SUNDRY NOTICES AND REPORTS ON WELLS
Do not use this form for proposals to drill or to re-enter an abandoned well. Use Form 3160-3 (APD) for such proposals.

8. Well Name and No.
Keetom Jicarilla No. 001

**Enervest Operating, LLC respectfully requests authorization to plug and abandon this well.
Please see attached Plug and Abandonment Procedure, Wellbore Diagrams and Site Reclamation Plan.**

CONDITIONS OF APPROVAL

Proposed P&A

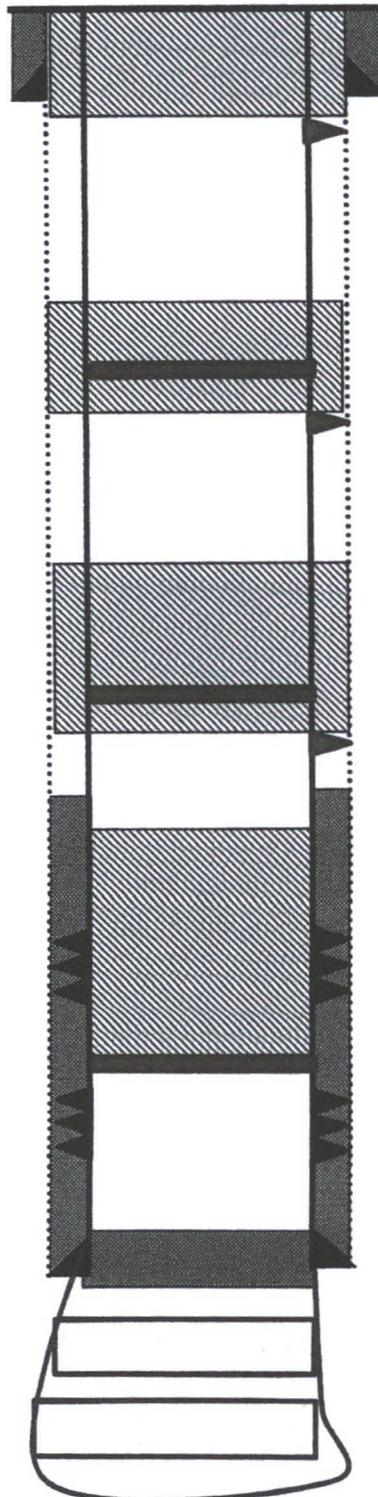
1. Plugging operations authorized are subject to the attached "General Requirements for Permanent Abandonment of Wells on Federal and Indian Lease."
2. Farmington Office is to be notified at least 24 hours before the plugging operations commence (505) 564-7750.
 - a) Set Plug #3 (1143'-1043') ft inside/outside. to cover the Nacimiento top. BLM picks top of Nacimiento at 1093' ft.
